Re: Casa Del Rey Parking Lot Grading and Drainage Engineer's Stamp Dated 3-12-02, (H11/D64)

RE: Casa del Rey Parking Lot (H11/D64)

Re: Casa del Rey Parking Lot Grading and Drainage Plan Engineer's Stamp Dated 3-12-02, (H11/D64)

Casa del Rey Parking Lot

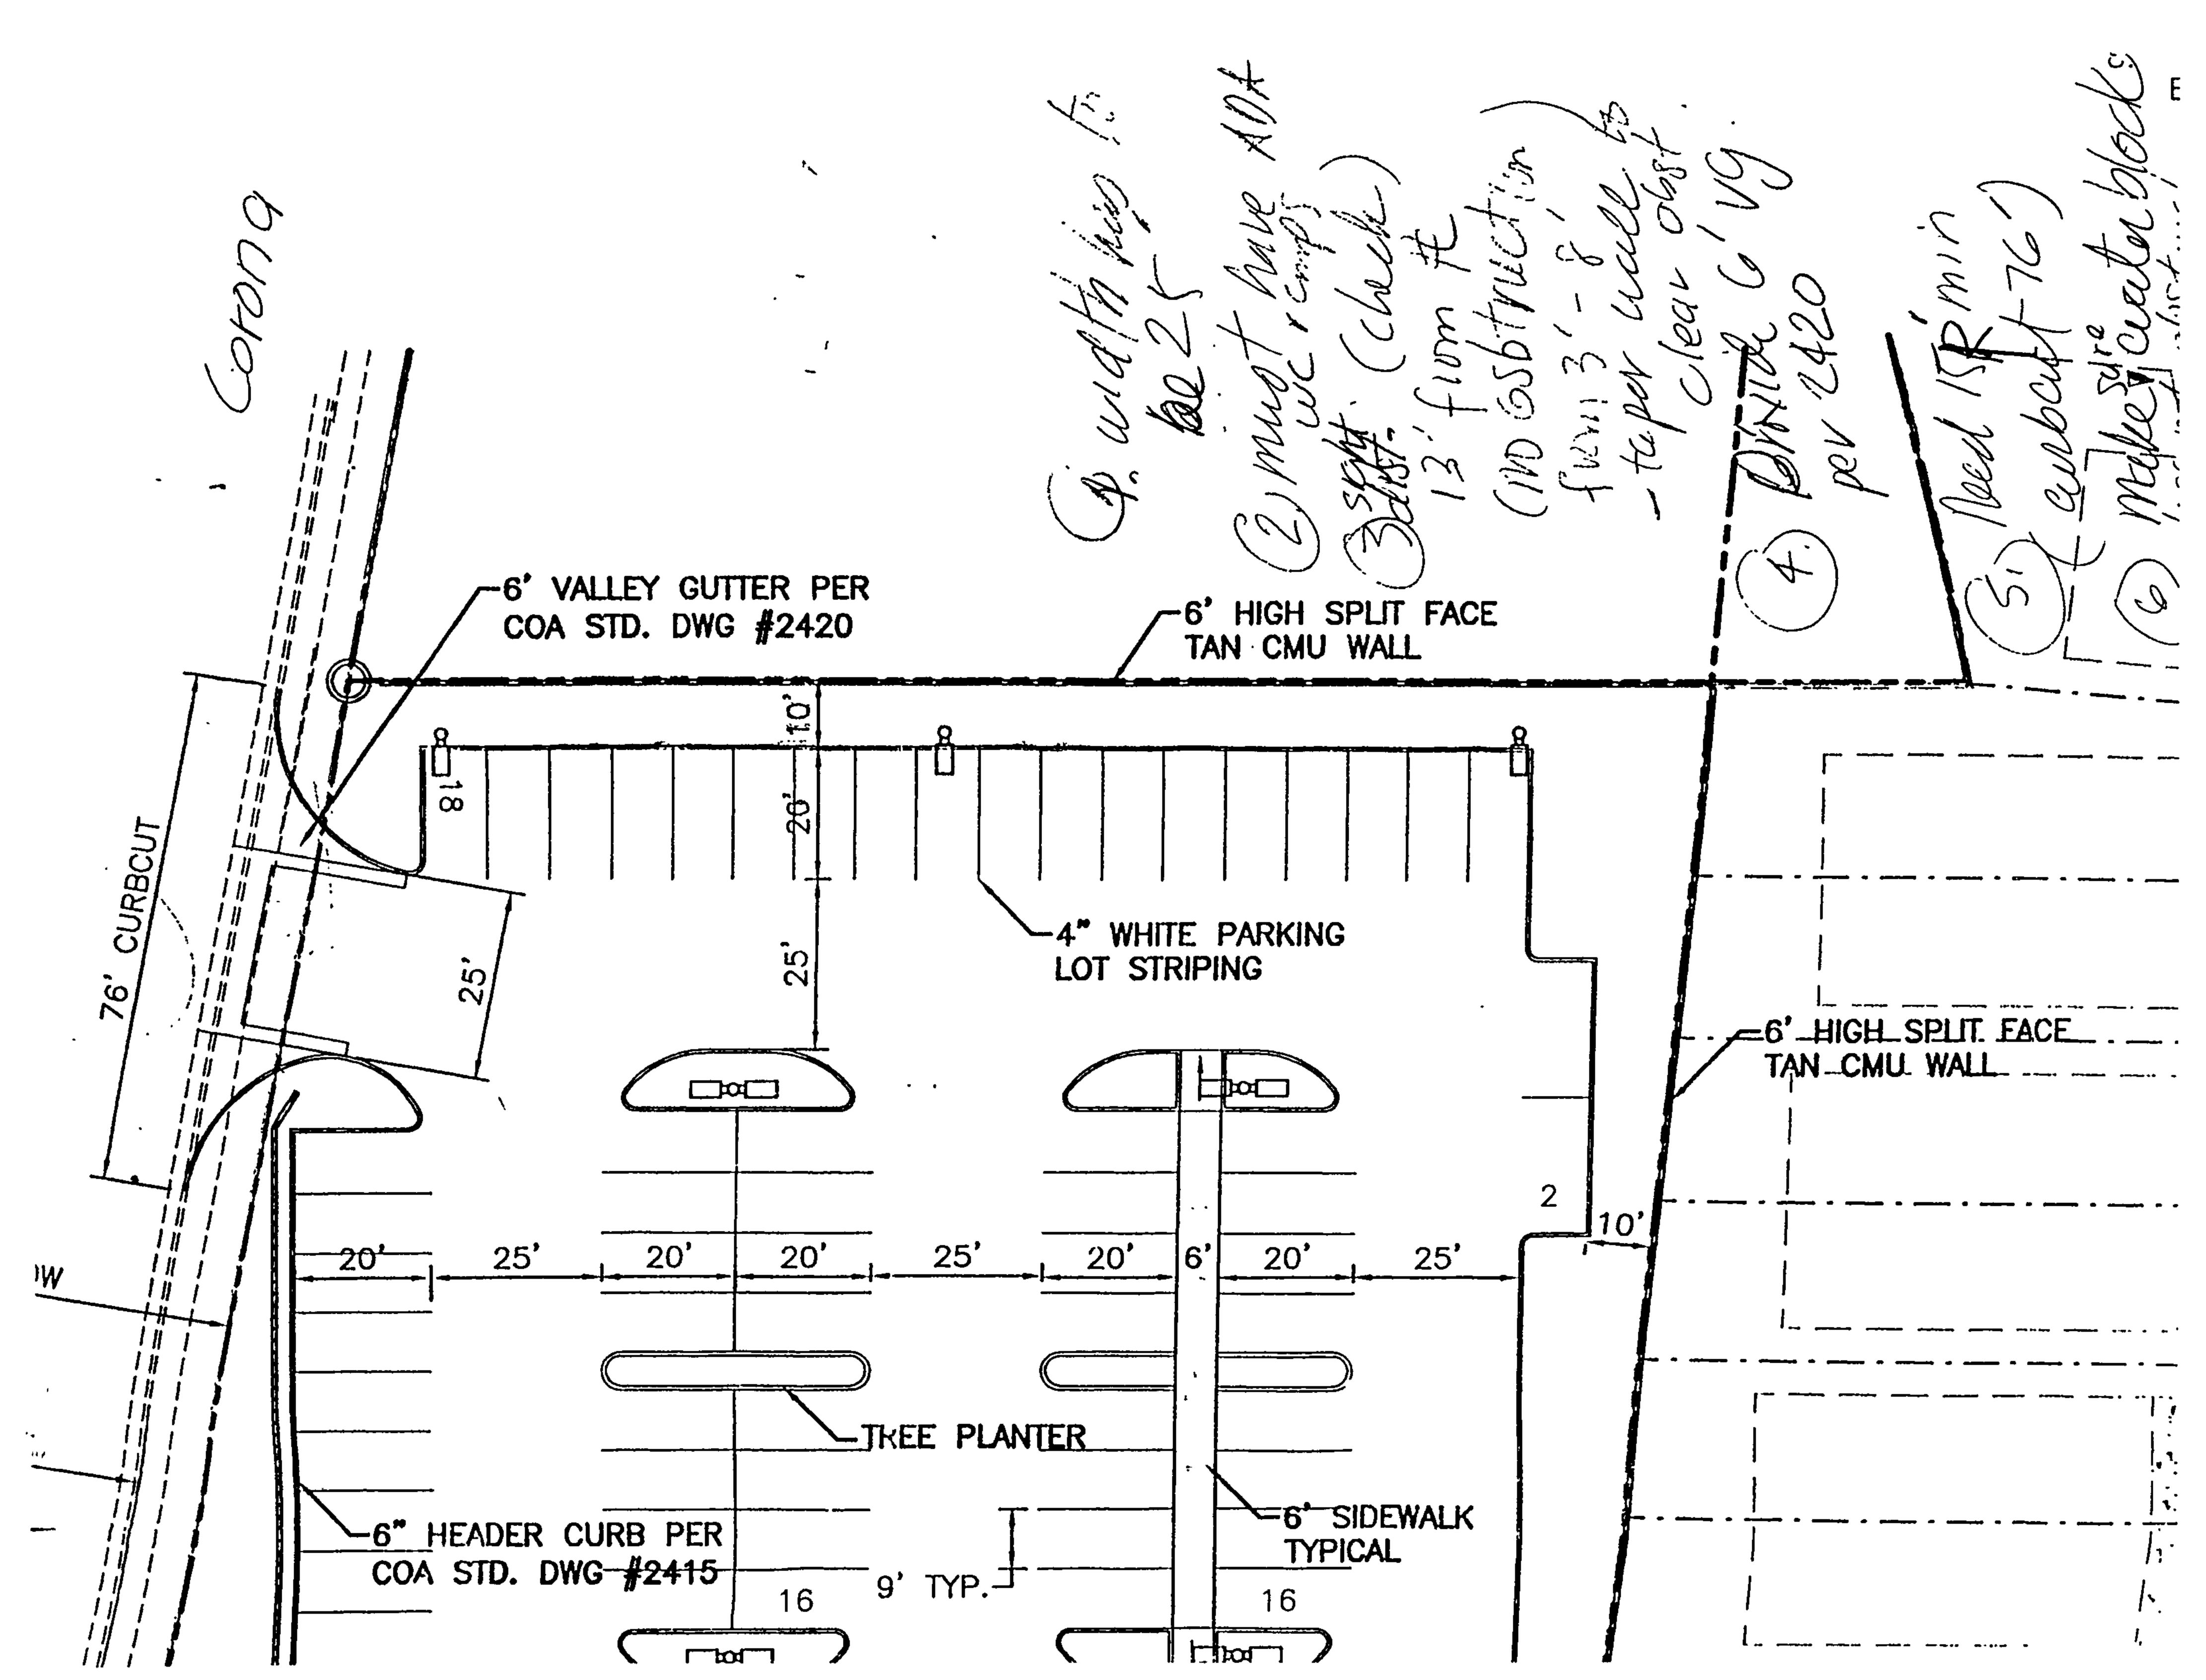
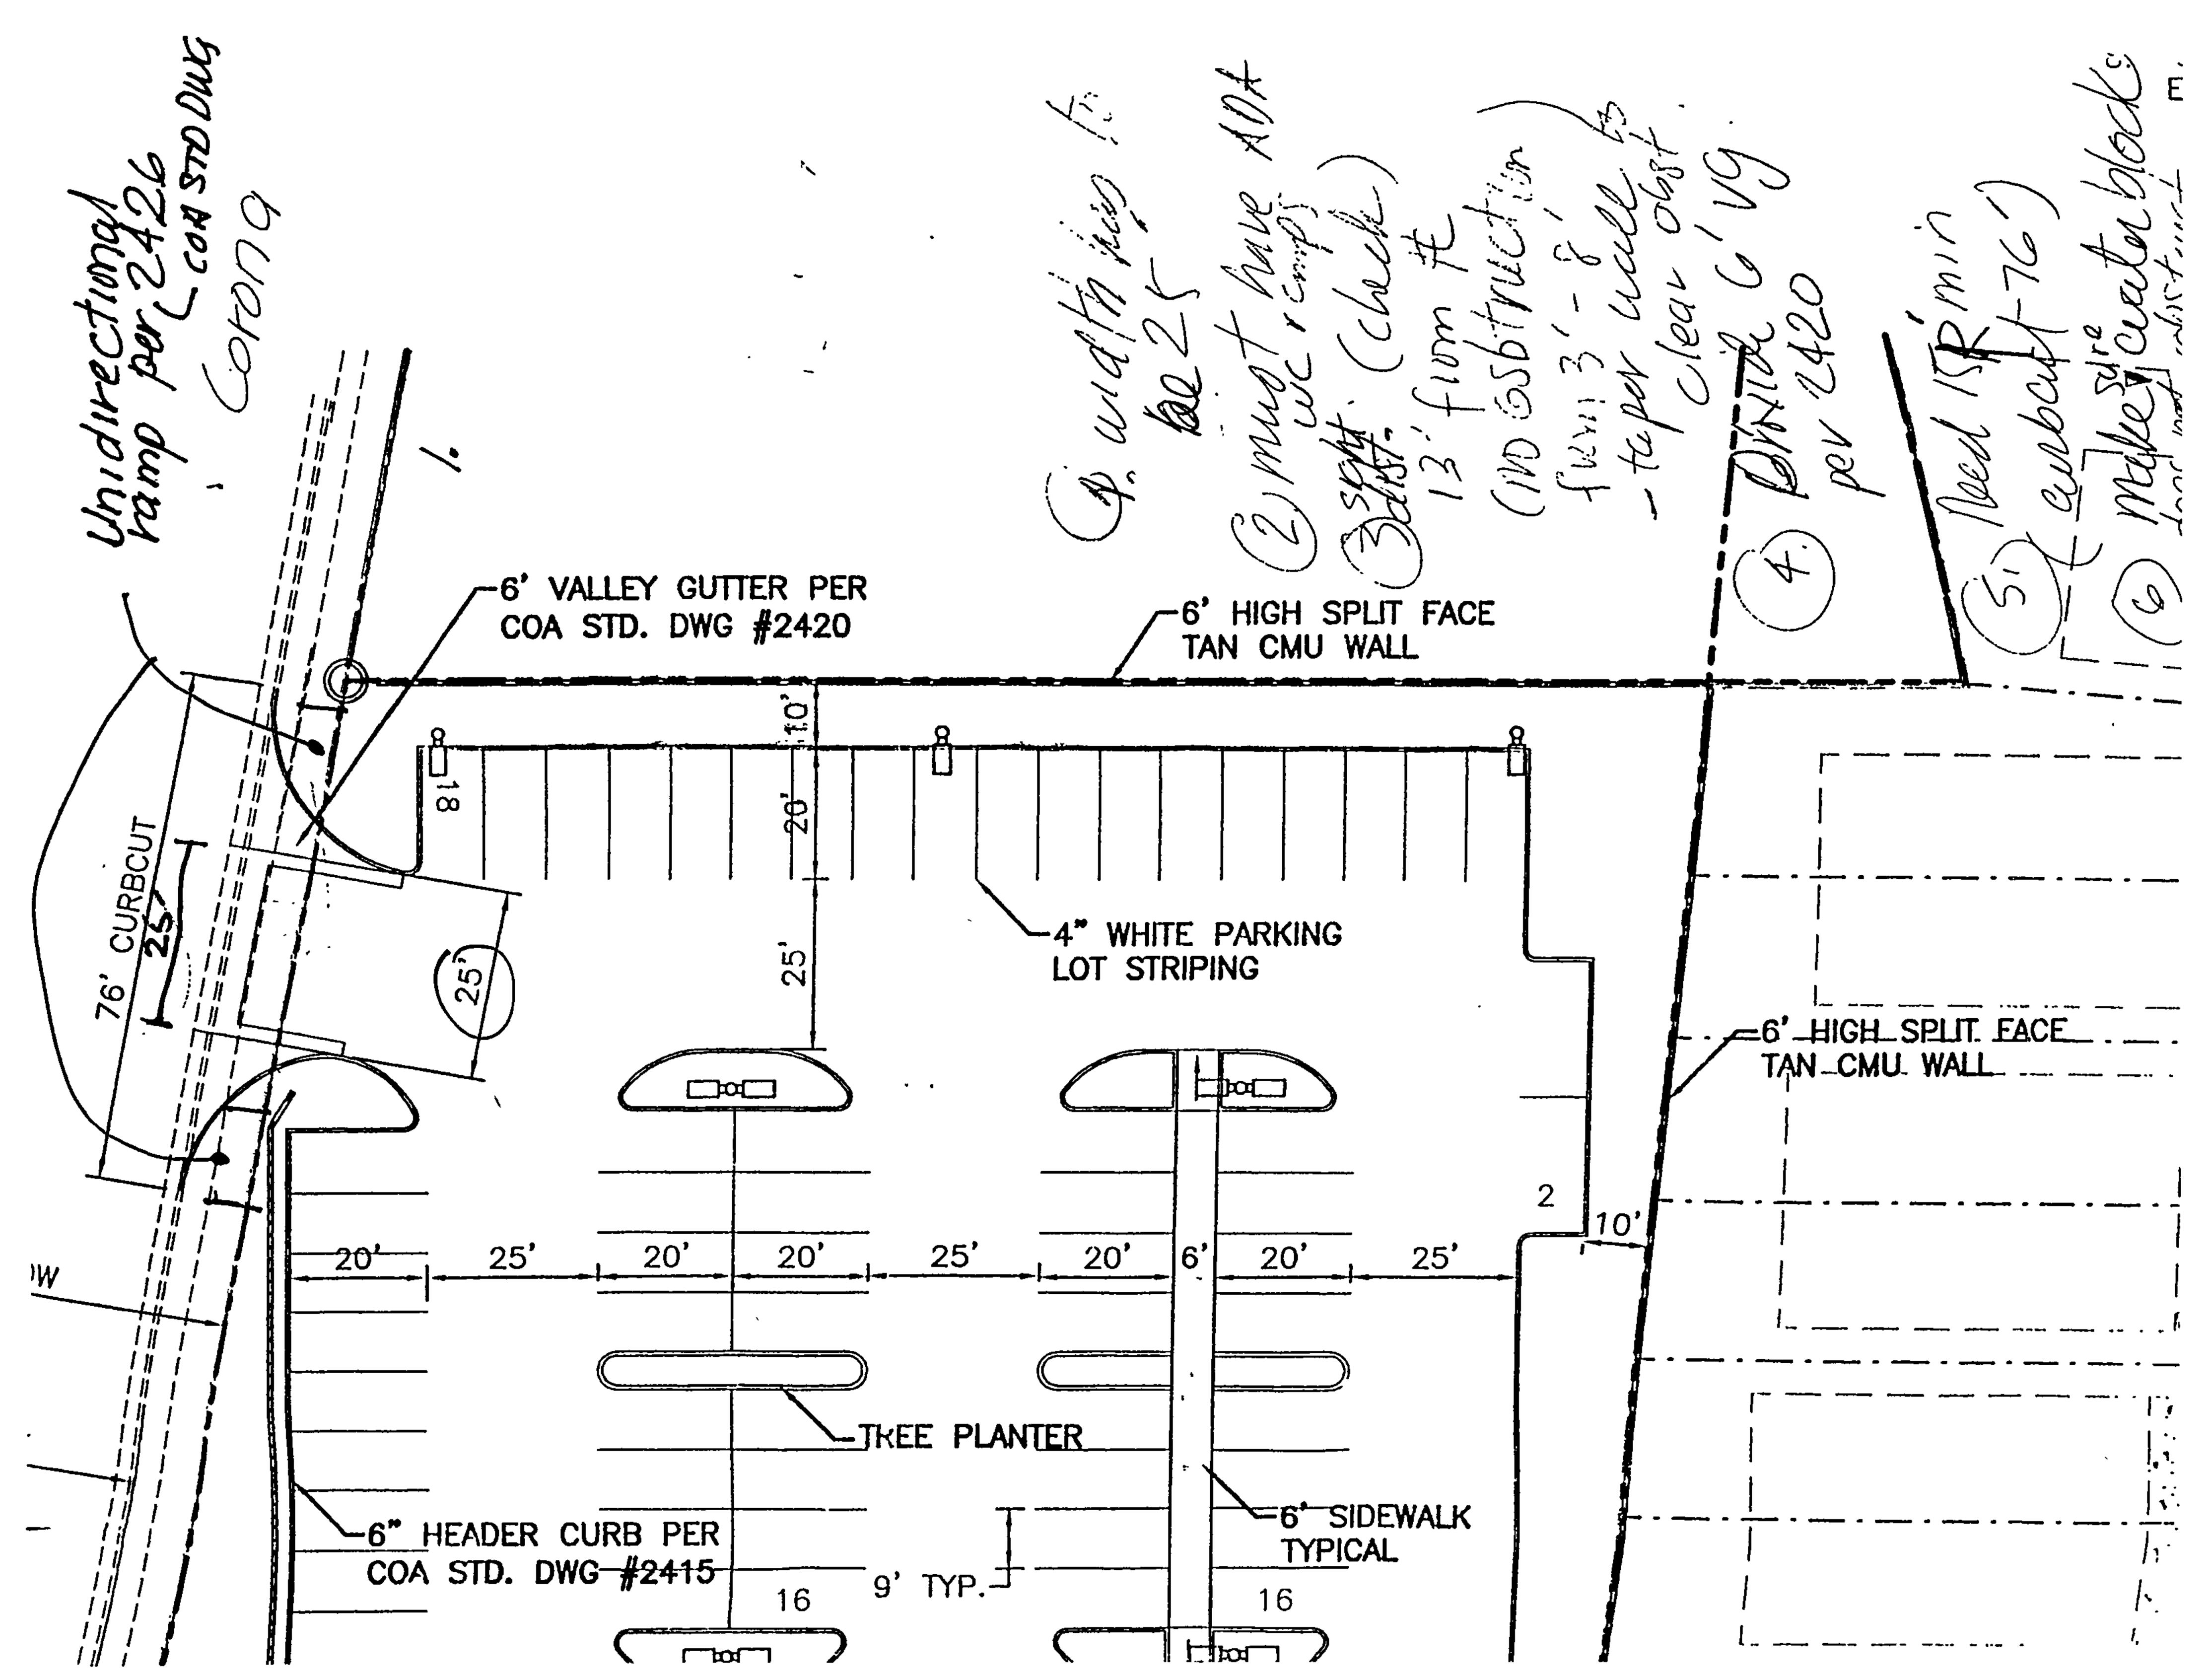
- The submittal of this site plan to the DRB shall meet all EPC conditions. A letter shall accompany the submittal, specifying all modifications that have been made to the site plan since the EPC hearing, including how the site plan has been modified to meet each of the EPC conditions. Unauthorized changes to this site plan, including before or after DRB final sign-off, may result in forfeiture of approvals.

- 2. The submittal shall contain language stating that the site will be in compliance with Section 14-16-3-9, Areas Lighting Regulations of the Comprehensive City Zoning Code.

- 3. The applicant shall provide the accurate number of trees along the east and north 10' wide landscape buffer areas as determined in the Comprehensive City Zoning Code.

- 4. A notation shall be provided on the submittal that ensures the use of this off-street parking area to be utilized in connection to the adjacent church site located on Lot A, First Spanish Assembly of God Church, zoned SU-1 for Church and Related Facilities. This condition shall not be deemed as preventing establishment of mixed use parking agreement at a future date.

1. Driveway to be 25' wide.

We are in compliance with Section 14-16-3-9, Areas Lighting Regulations.

We have designated the appropriate number of trees as required by the Comprehensive Zoning Code.

parking is to be used as off-street parking in conjunction. Assembly of God Church and Related Facilities.

As requested by the City Engineer the Driveway is to be 25, wide at
